No. 92-10

OFFICIAL NOTIFICATION UNDER THE U.S. FEDERAL BOAT SAFETY ACT

A. REQUIRED DISTRIBUTOR CAP GASKET INSTALLATION

MCM 4.3L/4.3LX Stern Drive Engines

Figure 1

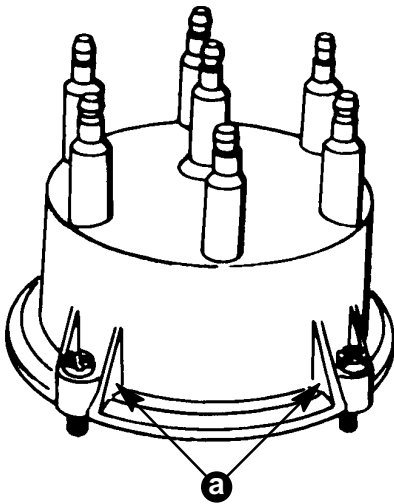
The distributor cap with reinforcement ribs by the hold-down screws (Figure 1), may not seal tight enough to comply with SAE J1171 "External Ignition Protection of Marine Electrical Devices" regulations. There may be a gap between the cap and the distributor housing. This gap may reduce the explosion arresting ability of the distributor assembly creating the potential for fire or explosion if gasoline or a gasoline vapor source is present.

1. Open engine hatch and look at distributor cap.
 - a. If the cap has reinforcement ribs (a) as shown in Figure 1, go to Step 2.
 - b. If cap does not have reinforcement ribs (b) as shown in Figure 2, go to Step 5. This cap complies with SAE J1171 and is not affected by this recall.

2. Remove cap to see if gasket has been installed in cap.
 - a. If there isn't a gasket, go to Step 3.
 - b. If there is a gasket, go to Step 4.
3. Install gasket P/N 27-98242--1 in cap.
4. Reinstall cap and tighten hold down screws securely.
5. Close engine hatch.
